Stakeholder Comments Template

Hybrid Resources

This template has been created for submission of stakeholder comments on the Hybrid Resources Issue Paper that was published on July 18, 2018. The paper, stakeholder meeting presentation, and other information related to this initiative may be found on the initiative webpage at:

Submitted by	Organization	Date Submitted
ALI CHOWDHURY, PhD, MBA Vice President – Transmission & Interconnection Phone 916.990.8027	8minute Solar Energy	8/12/2019

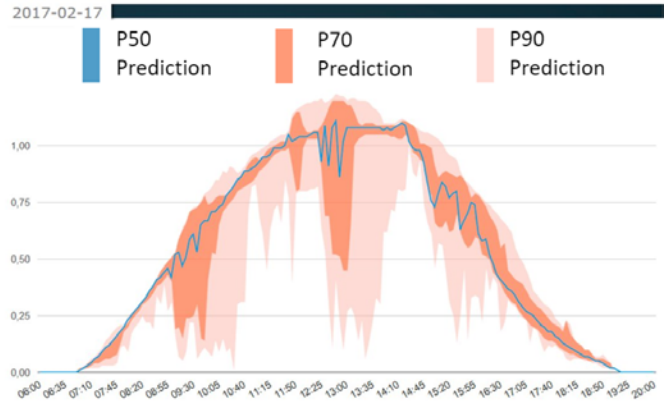
The process by which the BESS gets to 4 hours of charged energy when grid charging is not allowed should be managed using the highest quality PV forecast and algorithms that accommodate account for consider both when are the lowest grid prices of the day and solar availability make sure to charge the BESS when solar is available to be charged. The ISO normally manages co-optimization for prices, but if the central dispatch expects to charge an ESS with no grid charging allowed from 1 PM to 3 PM and the solar is only generating intermittently during that time, the ESS will need to deviate from CAISO dispatch instructions ignore some of the charge commands . The ESS in that example should have started charging earlier in the day to make sure it charges only from solar and still is ready to meet the day ahead dispatch at 3 PM.

It is 8minute's understanding that the ISO does not use onsite cameras to inform PV generation forecasts. only has access to satellite based forecasts of PV generation and that it is not tuned for onsite conditions. 8minute has performed tests of multiple satellite forecast providers and onsite optical and thermal cloud imaging cameras. 8minute found that forecast quality of the next hour improved by ~200% when using onsite thermal imaging and advanced machine learning to provide feedback to the forecast provider based on what actually occurs onsite . 8minute includes ensemble satellite based forecasts with onsite thermal cloud imaging and advanced machine learning feedback of the of PV generation to improve the forecast. This capability should be provided by an ensemble forecast of satellite plus onsite thermal cloud imaging or purchase an ensemble forecast from one known vendor. Without this more advanced forecast 8minute expects the ISO to struggle to manage grid charging and maintain reliability.

SUGGESTED POLICY: If the ISO cannot or will not provide this forecast and more advanced battery state of charge management using the forecast 8minute suggests the onsite storage plant controller be allowed to self-schedule charging or discharging in the 5 or 15 minute settlement interval. The onsite storage plant controller will prevent the two resources from exceeding the project Interconnection Limit.

- Forecast error is managed in each timestep by providing a forecast range with probability
- BESS controls are designed to adapt to the new forecast every minute and not overcommit to an uncertain forecast

Controls to accommodate “AC-oversized” plants

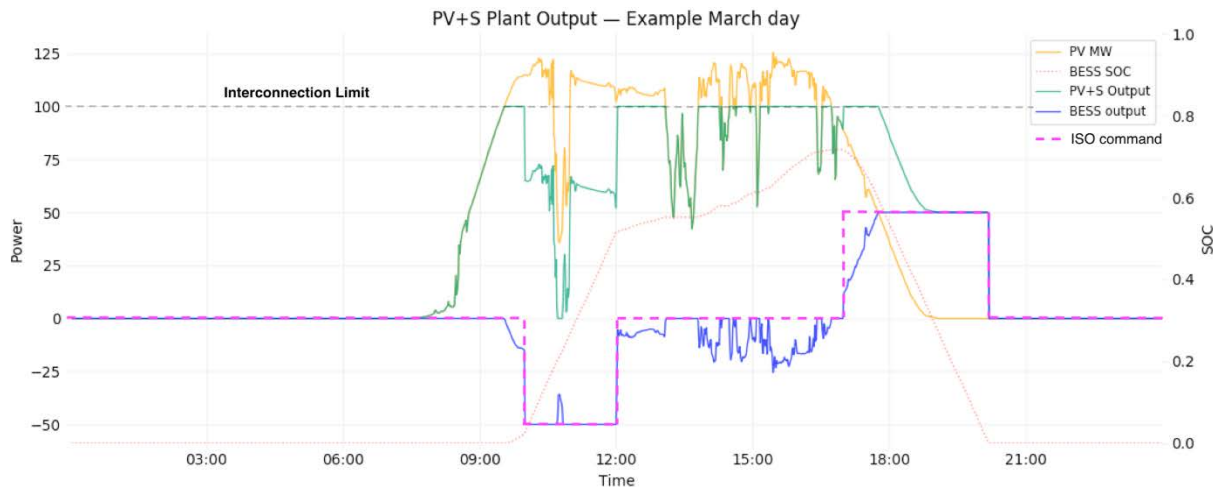
An AC-oversized project is one in which the solar generation is intentionally built larger than the Interconnection Limit and a storage system is included to capture energy generated in excess of the Interconnection Limit then discharge it when the solar generation is less than the Interconnection Limit. See the below illustration:

SUGGESTED POLICY:

The ISO should not make the excess generation the “marginal unit” for the local LMP and this should not have any impact on local price because it is managed inside the Hybrid Resource. In addition: (1) The Pmax of the solar resource in the ISO Master File should be allowed to exceed the Interconnection Limit; and (2) the applicable Resource IDs should be linked in the Master File to ensure that the market awards less on-site charging do not exceed the Interconnection Limit.

- (a) The existing Hybrid Resource Constraint should include the option for the energy storage system to self-schedule charge of PV generation in excess of the Interconnection Limit instead of allowing the PV to be curtailed.
- (b) The solar onsite plant controller should report via telemetry the current solar generation and the potential solar generation. Potential solar generation being the solar generation without any economic curtailment or Interconnection Limit curtailment. If the potential solar generation is greater than the Interconnection Limit and the storage facility can absorb it, the ISO should instruct the storage resource to charge from excess generation.
